**LEGAL ADVERTISEMENT
PORTLAND PLANNING BOARD MEETING**

- i. Level III Site Plan and Subdivision; 17 Carleton Street; Avesta Housing, Applicant. (7:00 – 8:30 p.m. estimated time) The Board will hold a public hearing on a 37 unit affordable housing project with a total floor area of 26,375 sq. ft. and a building footprint of 5,495 sq. ft. The bedroom mix is for 9 efficiency, 26 one-bedroom and 2 two-bedroom units. A total of 31 parking spaces are proposed for this project.

- ii. Level III Site Plan and Subdivision; 605 Stevens Avenue; Motherhouse Associates, LP, and Sea Coast at Baxter Woods Associates, LLC, Applicants. (8:30 p.m. estimated time) The Board will hold a public hearing on the proposed rehabilitation of the former St. Joseph's Convent (Motherhouse) into 88 units of senior housing, with 66 affordable units and 22 market rate units. The overall property includes 18.98 acres and the proposal includes subdividing the McAuley campus into four lots. Seventy-three (73) parking spaces with 9 handicap spaces are proposed on Lot 3 (4.39 acre lot) for the Motherhouse Senior Housing.

Memorandum
Planning and Urban Development Department
Planning Division

REV.	DATE	DESCRIPTION
1	5/7/15	ISSUED FOR SUBDIVISION & SITE PLAN APPROVAL
2	6/30/15	REV'D PER STAFF REVIEW AND COMMENTS
3	7/28/15	REV'D INFILTRATION SYSTEM, ADDED DETAIL 8
4	8/5/15	REV'D INFILTRATION BASIN

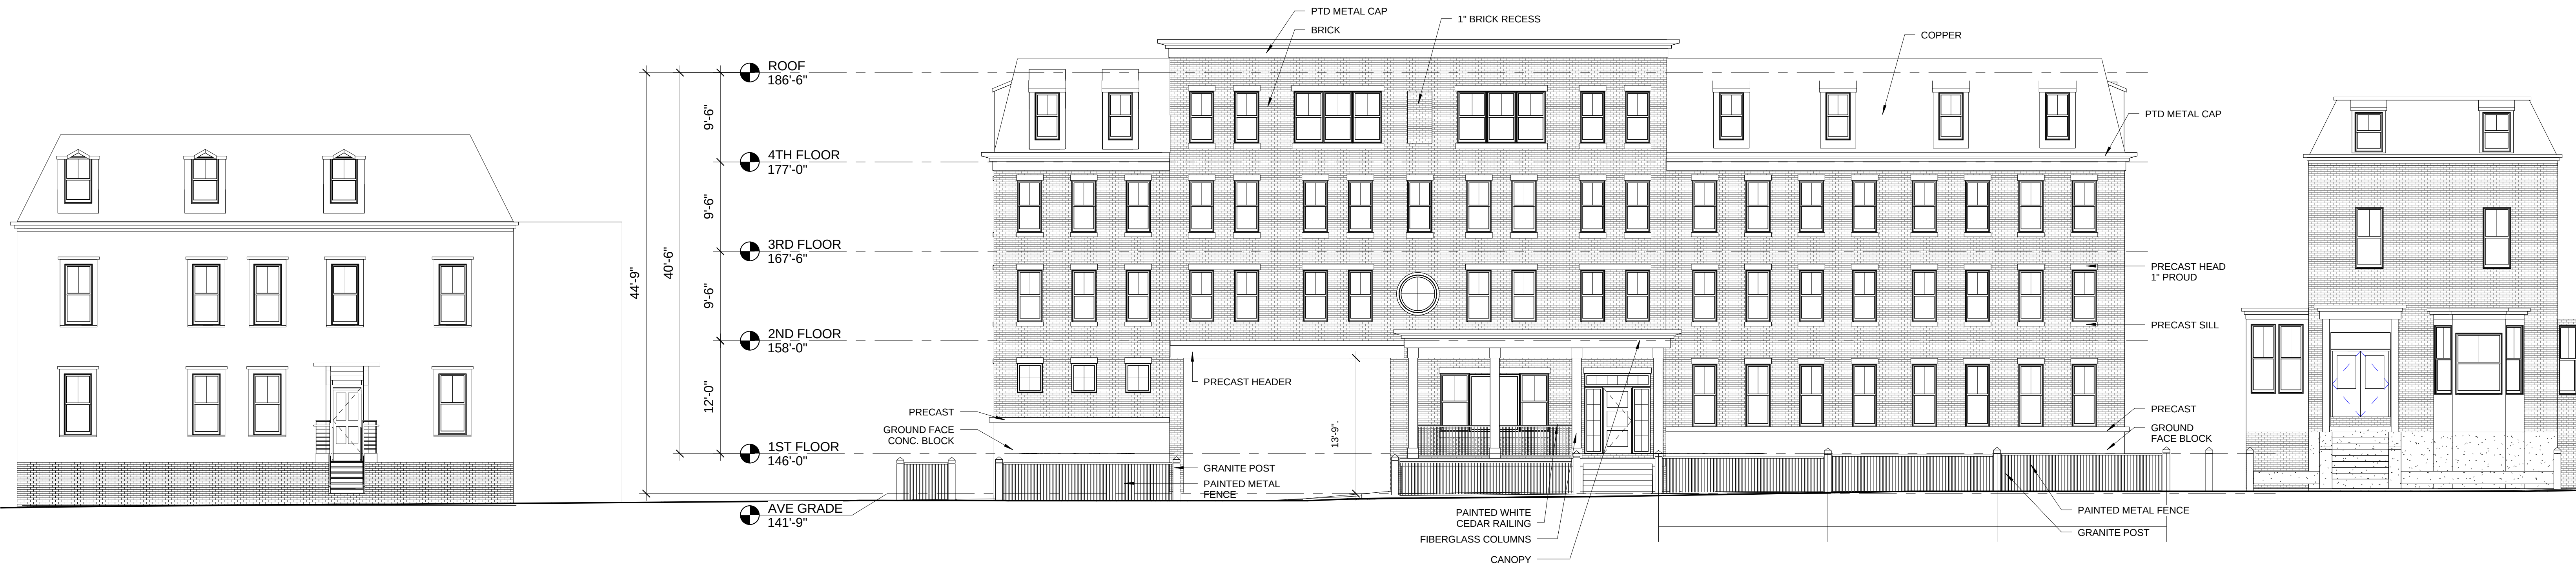
A remnant dimension of 12" for the ¾" crushed stone layer exists on C2.2 in the "Infiltration Basin Longitudinal Section" detail. This dimension is intended to be 3.4', and should be updated as part of final plan submittals, and can be made a Condition of Approval as needed.

3. A remnant dimension of 12" for the ¾" crushed stone layer exists on C2.2 in the "Infiltration Basin Longitudinal Section" detail. This dimension is intended to be 3.4', and shall be updated as part of final plan prior to the issuance of the building permit.

SHEETC6.0

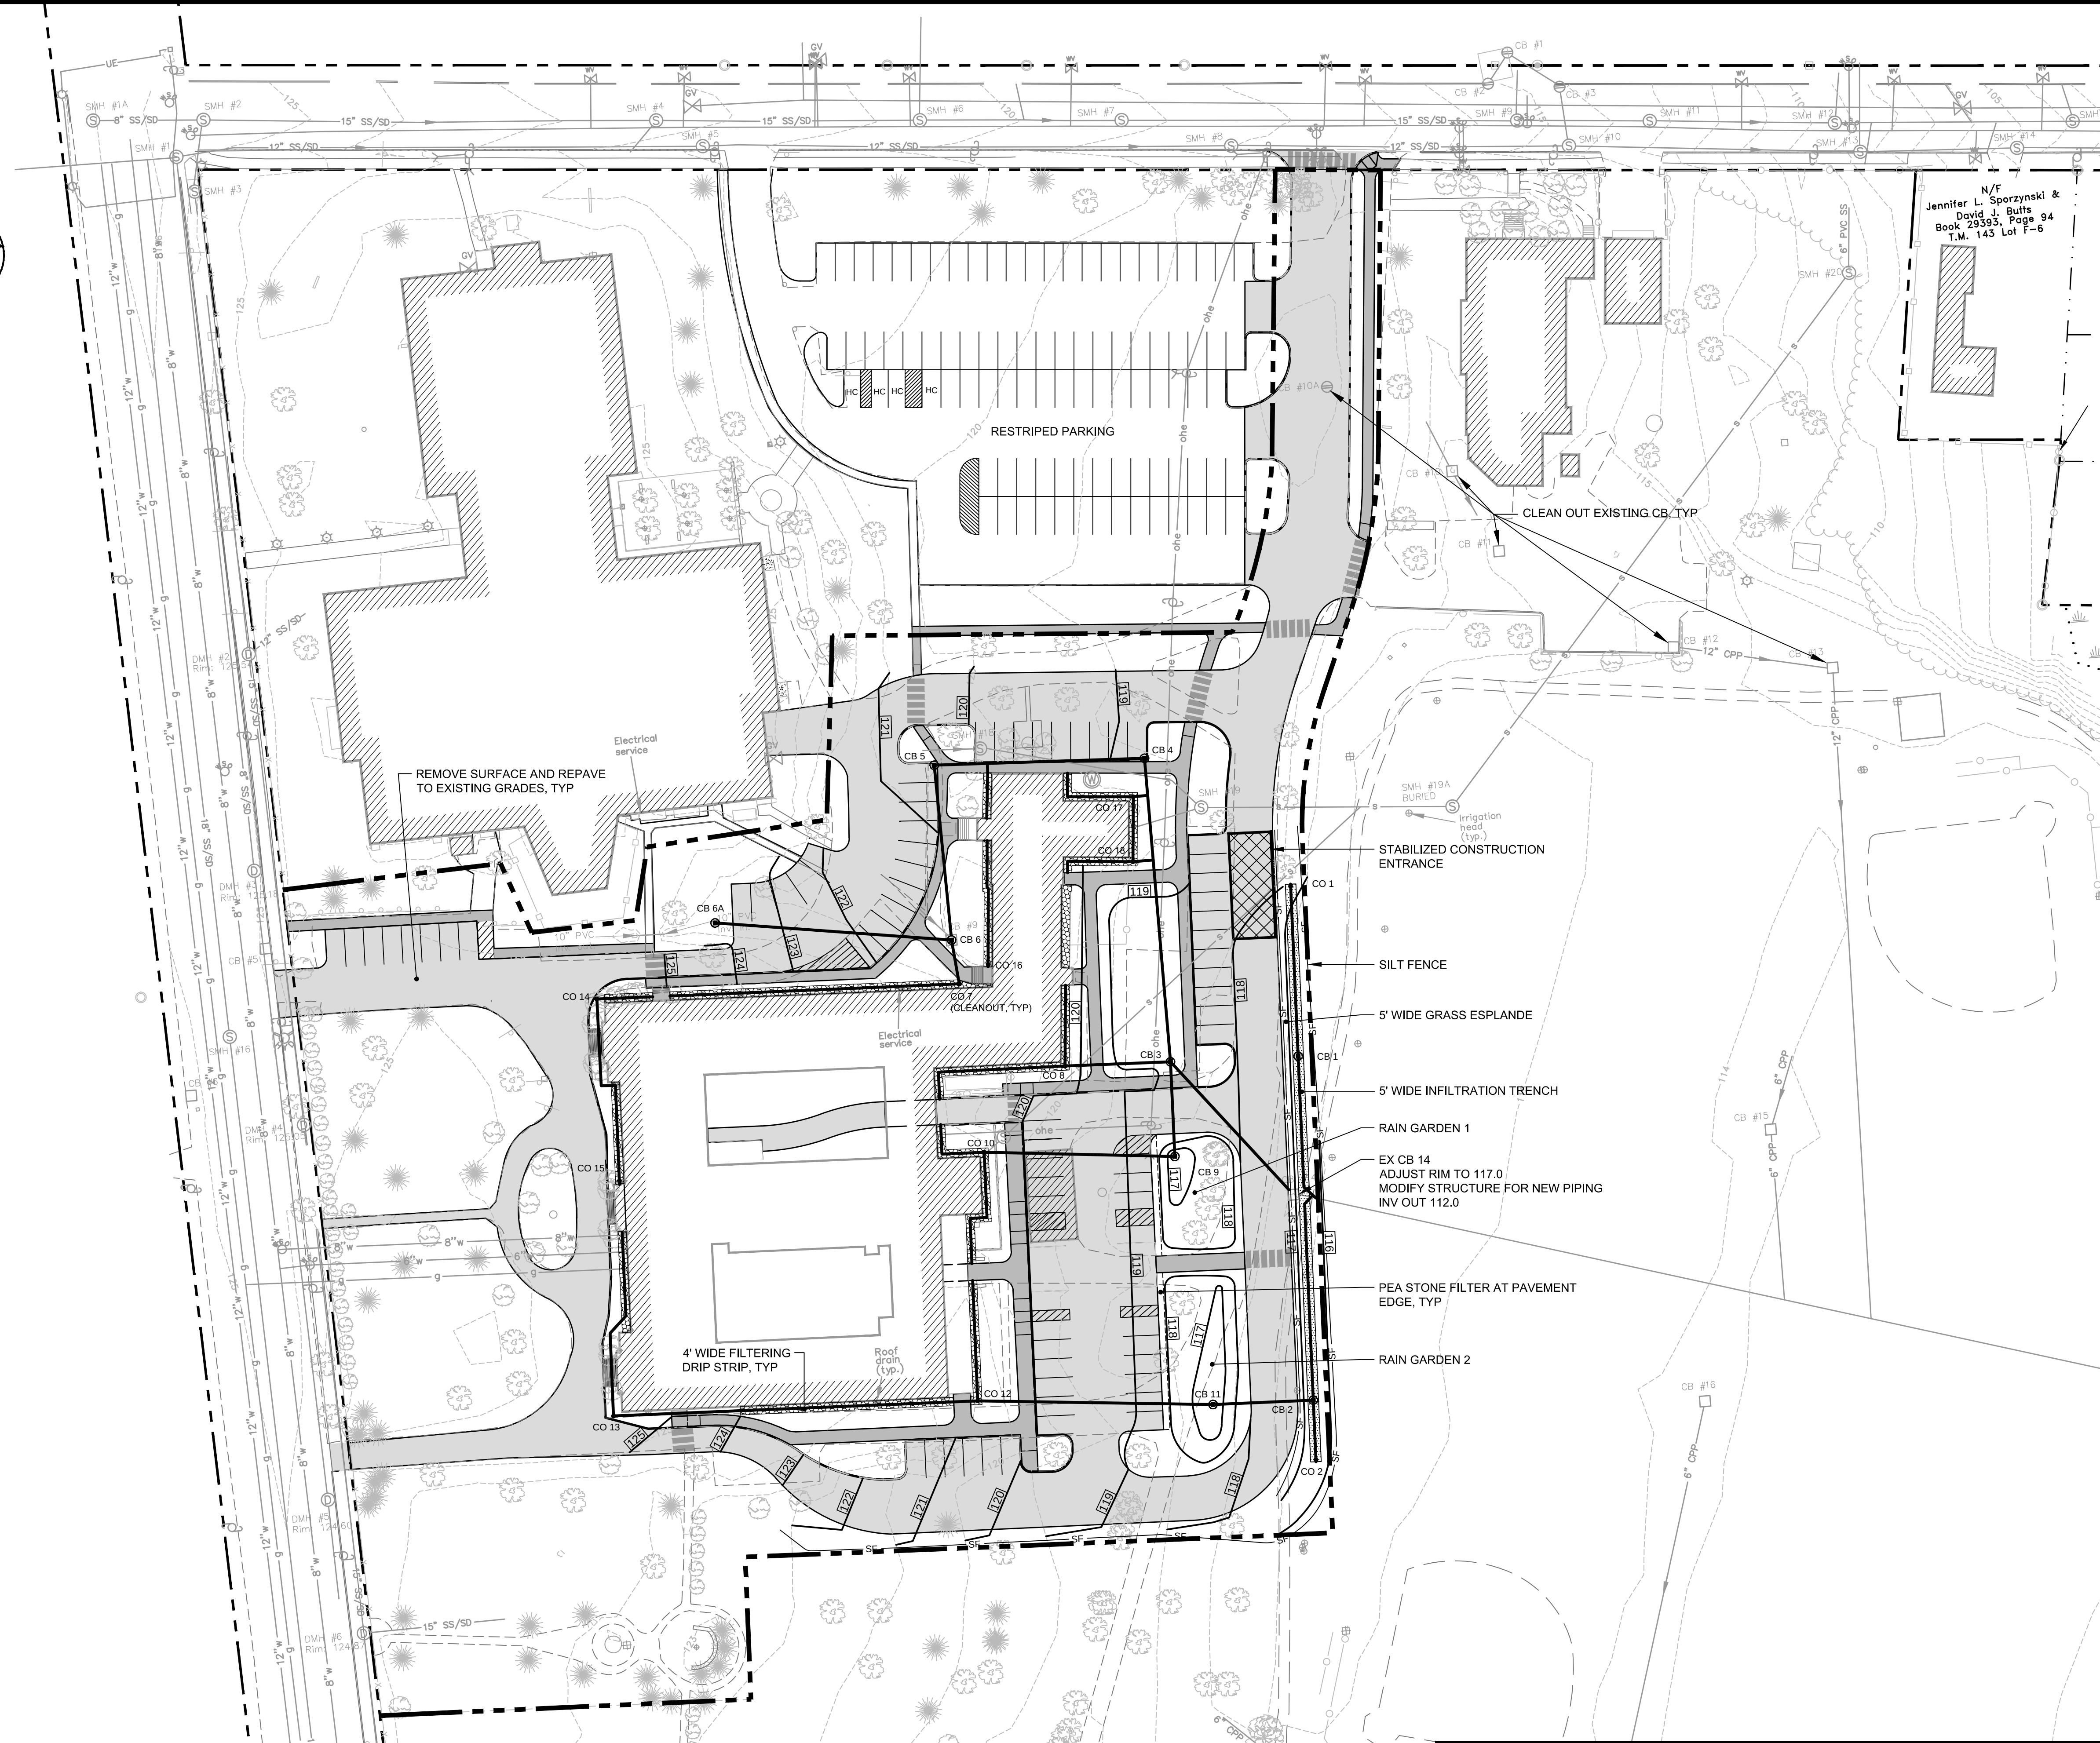
5) Sheet C-6.0 – Some of the cleanouts in plan-view are not numbered, and therefore cannot be checked against the drain schedule.

5) Sheet C-6.0 – Some of the cleanouts in plan-view are not numbered, and therefore cannot be checked against the drain schedule.

Labels have been added to the plan view and a revised sheet C-6.0 is enclosed for review.

Labels have been added to the plan view and a revised sheet C-6.0 is enclosed for review.
